Informal document **GRSP-57-16-Rev.1**  
(57th GRSP, 18-22 May 2015,  
agenda item 13)

## **Proposal for the 02 series of amendments to Regulation No. 127 (Pedestrian safety)**

**Submitted by the expert from the European Commission as Chair of the Task Force on Bumper Test Area within the Informal Working Group on global technical regulation No. 9 Phase 2 – Proposal of amendments to ECE/TRANS/WP.29/GRSP/2015/8.**

"Figure 5A

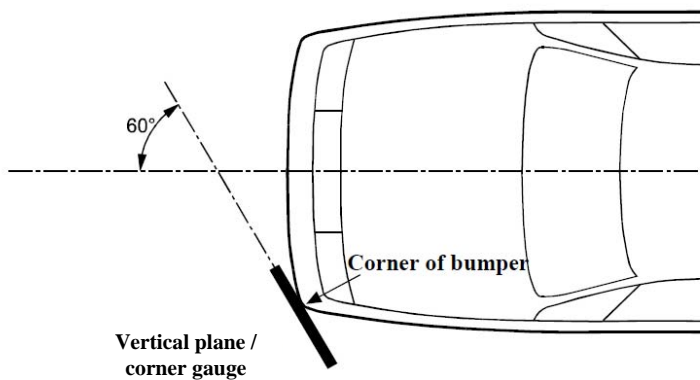
"2.17. **"Corner of bumper"** means ~~the transversal position of the vehicle's point of contact with a vertical plane which makes an angle of 60° with the vertical longitudinal plane of the vehicle and is tangential to the outer surface of the bumper (see Figure 5).~~ **corner gauge as defined in Figure 5B.**

**For determination of the corner of bumper, the front surface of the corner gauge is moved parallel to a vertical plane with an angle of 60° to the vertical longitudinal centre plane of the vehicle (see Figures 5A and 5C) at any height of the centre point of the corner gauge between:**

Figure 5, amend to read:

Corner of bumper example (see paragraph 2.17., note that the corner gauge is to be moved in vertical and horizontal directions to enable contact with the outer contour/ front fascia of the vehicle)

Figure 5B  
Corner gauge

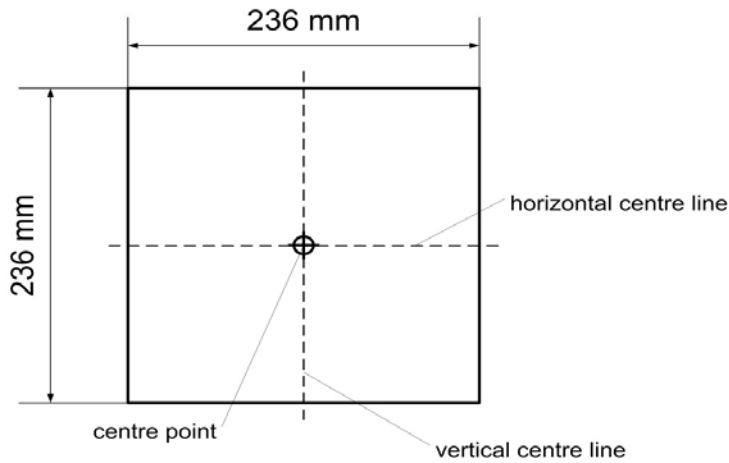
The front surface of the corner gauge is flat.

The centre point is the intersection of the vertical and horizontal centre lines on the front surface.

Figure 5C  
**Determination of the corner of bumper with the corner gauge (shown in random location)**

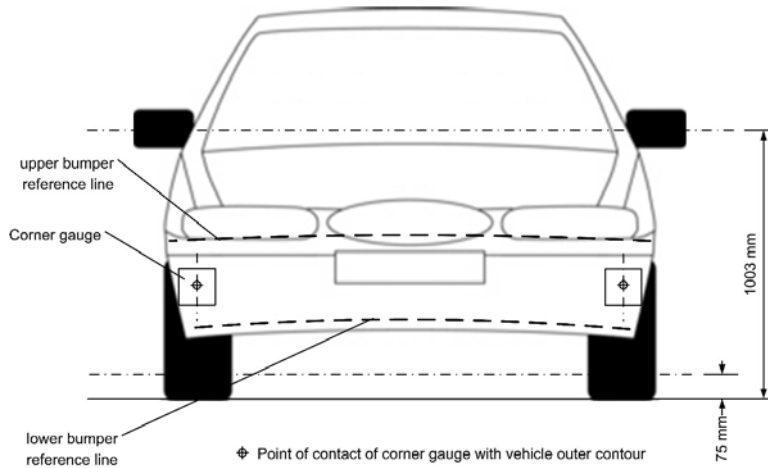
**For determination of the corner of bumper, the gauge is moved to contact the outer contour/front fascia of the vehicle touching at the vertical centre line of the gauge. The horizontal centre line of the gauge is kept parallel to the ground plane.**

Figure 5D  
**Determination of bumper test area (note that the corner gauges are to be moved in vertical and horizontal directions to enable contact with the outer contour/front fascia of the vehicle)**

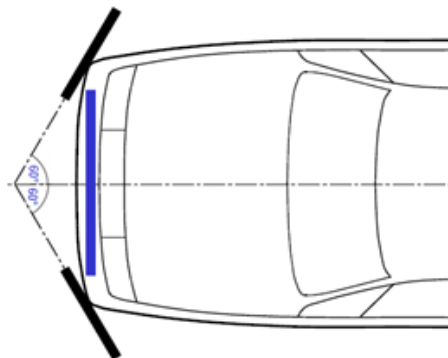
"2.14. **"Bumper test area"** means ~~the frontal surface of the bumper limited by two longitudinal vertical planes intersecting points 66 mm inside the defined corners of the bumpers. either the front vehicle fascia between the left and right corner of bumper as defined in paragraph 2.17., minus the areas covered by the distance of 42 mm inboard of each corner of bumper as measured horizontally and perpendicular to the longitudinal median plane of the vehicle with this distance to be set from the most outboard point with a flexible tape held tautly along the outer surface of the vehicle, or between the outermost ends of the bumper beam as defined in paragraph 2.12. (see Figure 5D), minus the areas covered by the distance of 42 mm inboard of each end of the bumper beam, as measured horizontally and perpendicular to the longitudinal median plane of the vehicle, whichever area is wider. This distance is to be set with a flexible tape held tautly along the outer surface of the vehicle.~~

5. For the bumper test area, the left and right corner of bumper are first determined through a revised method incorporating a corner gauge tracing the external front bumper fascia that determines the most outboard contact points.

6. During testing, injurious points have been found outside test areas defined by measurements dependent on the outer contour, particularly at the ends of the bumper beam when they extend beyond the left and right corner of bumper. For this reason, the entire width of the bumper beam should also be included in the bumper test area in the second step. Lastly, the widest area is selected for assessment.
